ADDENDUM NUMBER TWO

DUPONT PUMP STATION AND BASIN IMPROVEMENTS – PHASE 2 (Contract B) W-12-026-203

CITY OF CHATTANOOGA, TENNESSEE

SHEET: C-7

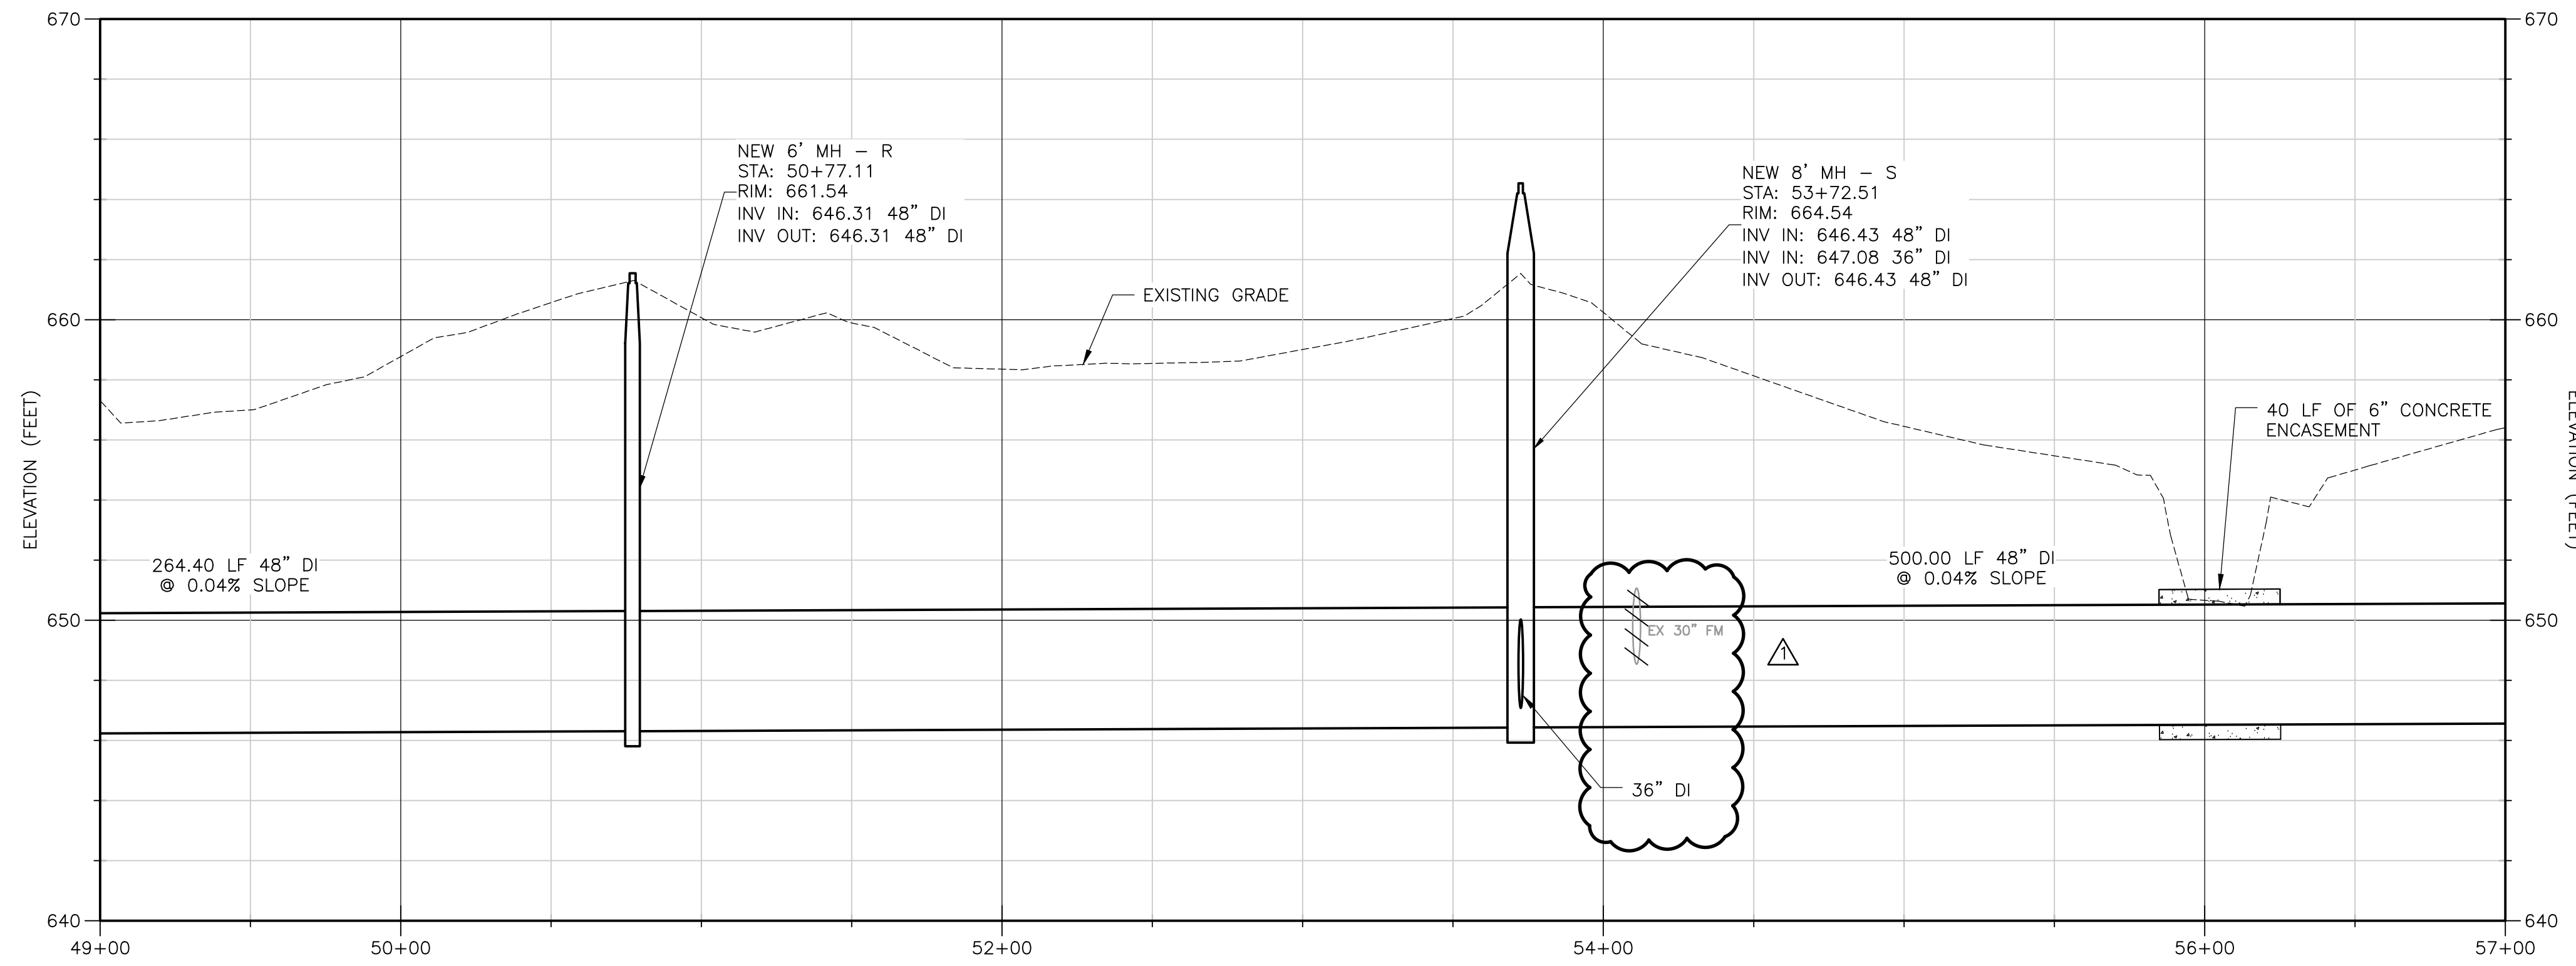
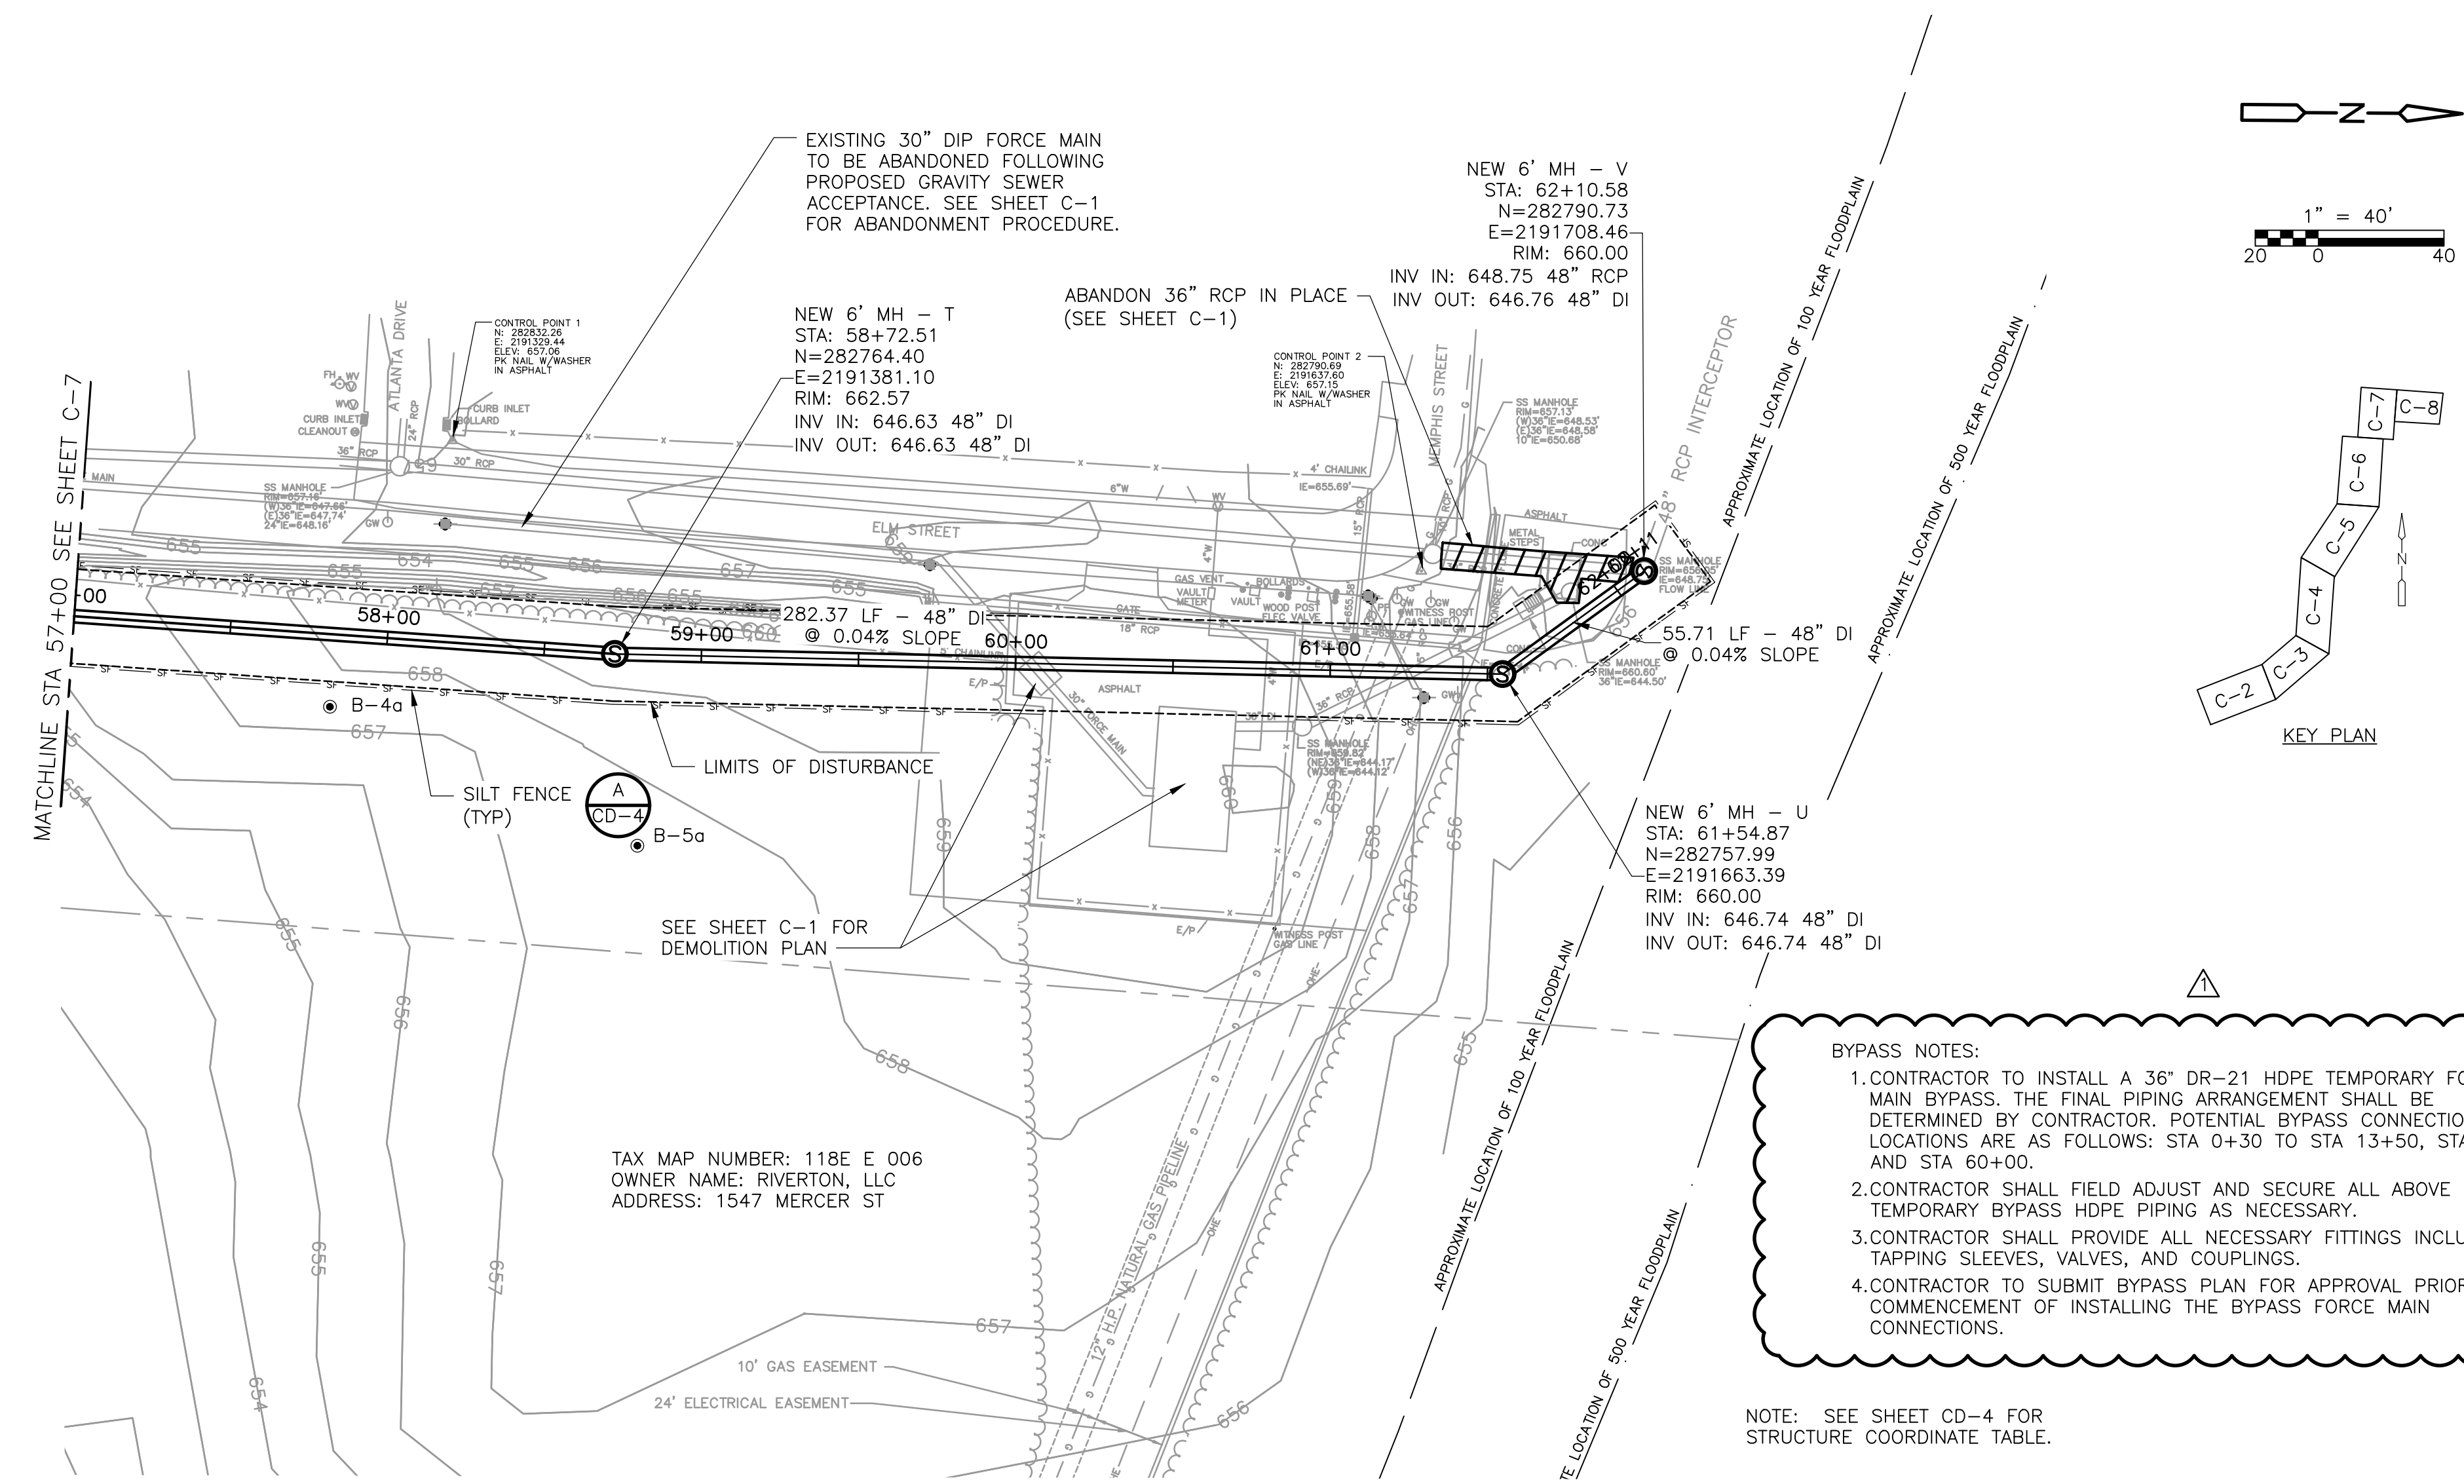
19. Reference sheet C-7. The existing 30" FM ends just north of the proposed MH Y. I do not believe this is accurate. Can you provide additional details of the 30" FM Route?

26. Line C profile on sheet C-9 shows the 36" pipe as DIP, but on sheet C-7 manhole S shows a 36" FRP pipe going to the manhole. Is this the same line or a different line and if it is the same line is this line supposed to be DIP or FRP?

Response: 30" Force Main is parallel to the existing 36" RCP. This is shown on the revised sheets.

Response: The pipeline is to be ductile iron. See revision above.

SHEET C-8

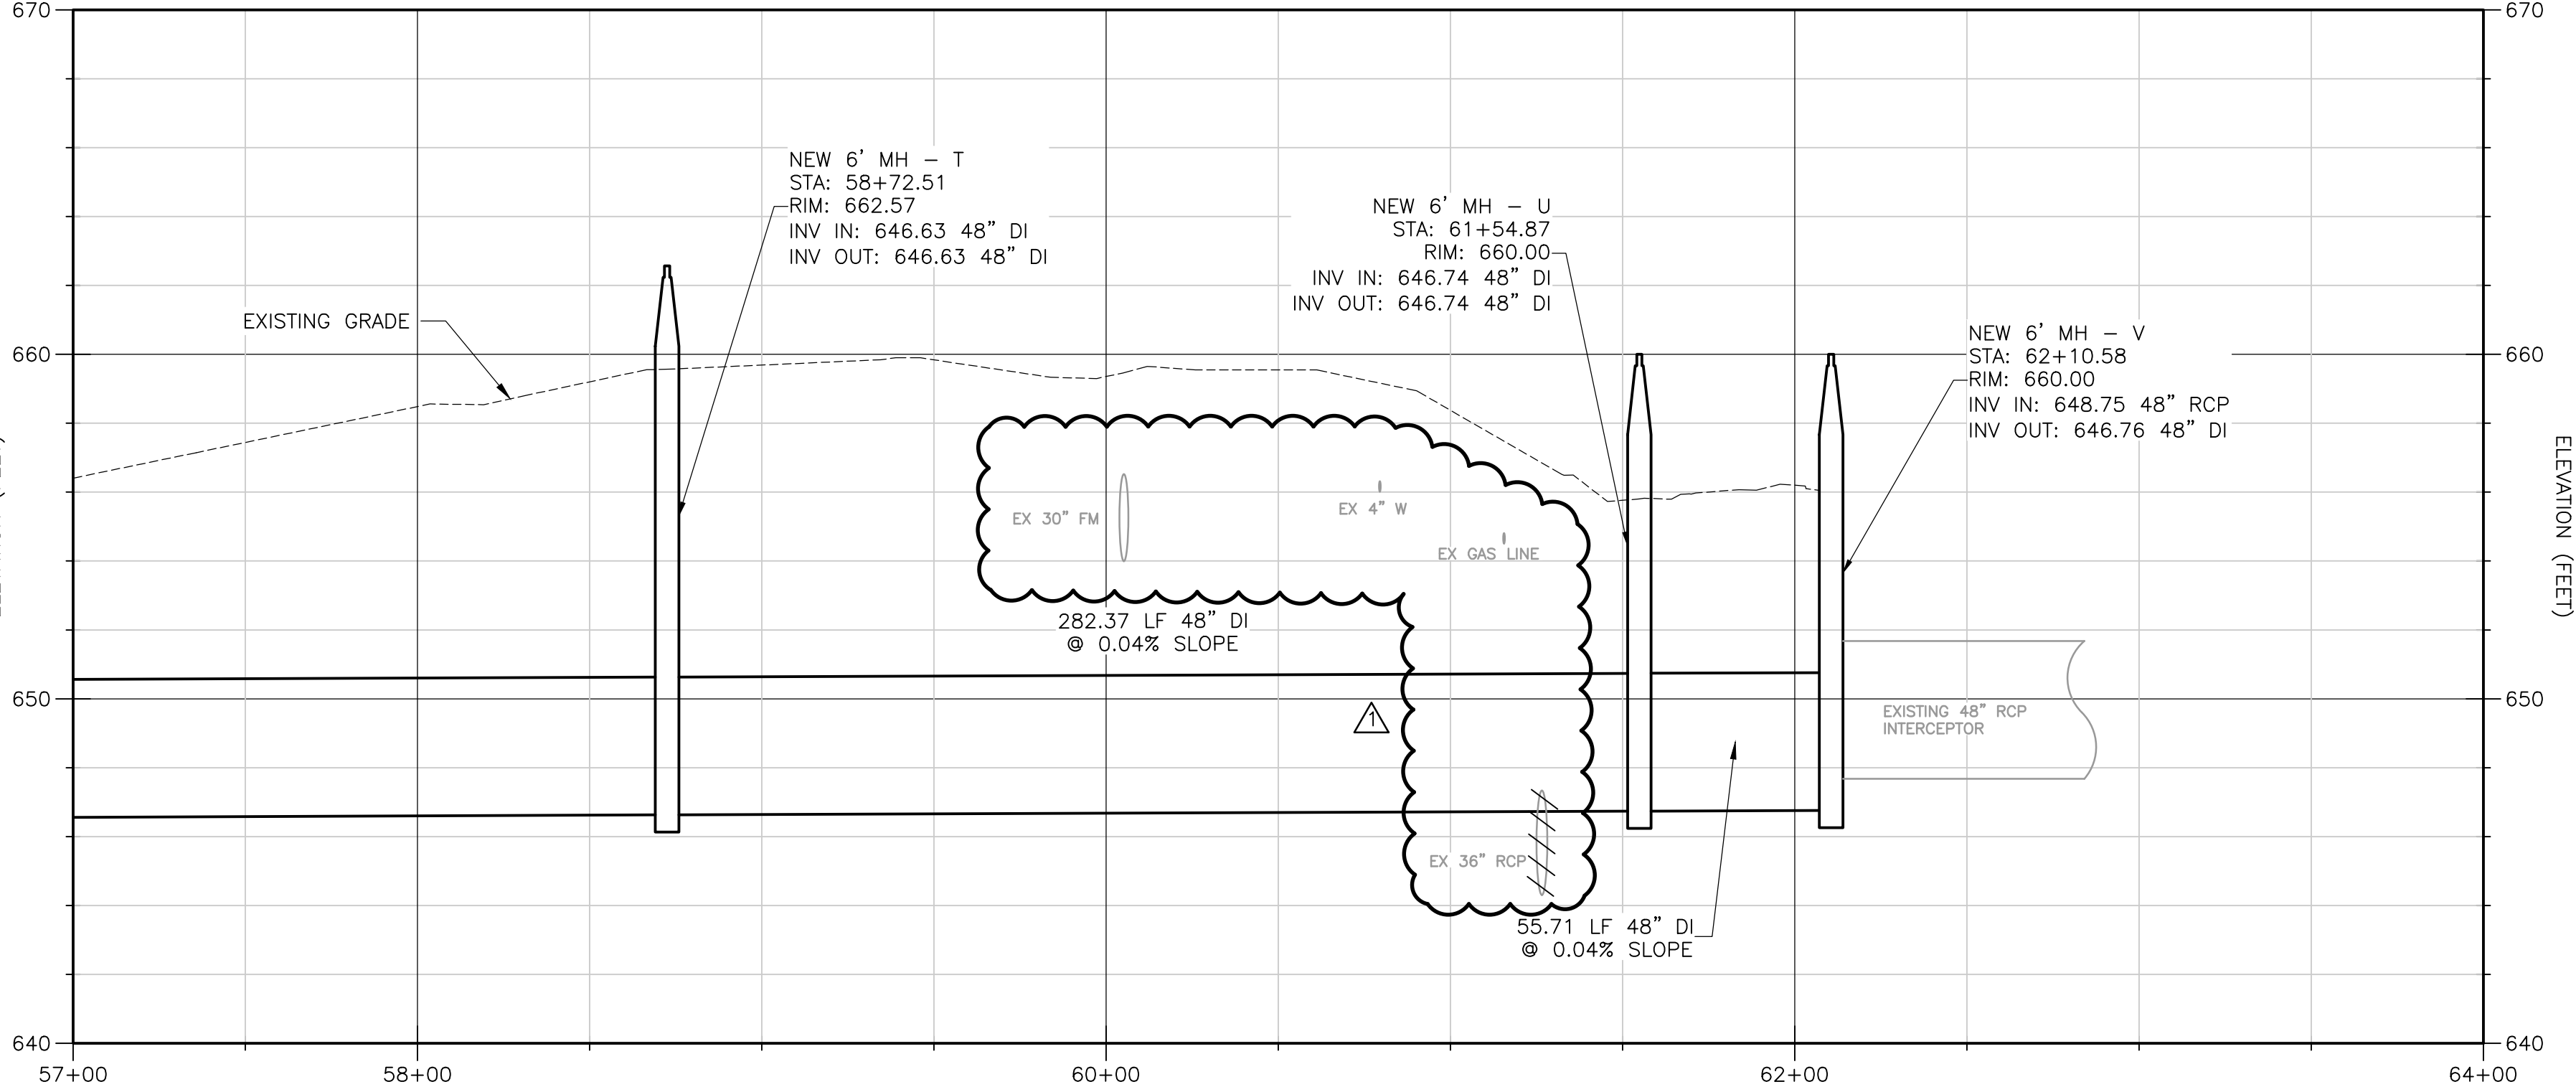
30. The plan sheets provided don't show on the profile the elevation of the existing pipes and structures that the 48" gravity sewer will be going through and/or over/under. Can these be added to the plans to know what will have to be taken out during the proposed sewer installation?

Response: The existing force main has been added to the profiles. See revisions attached to this addendum.
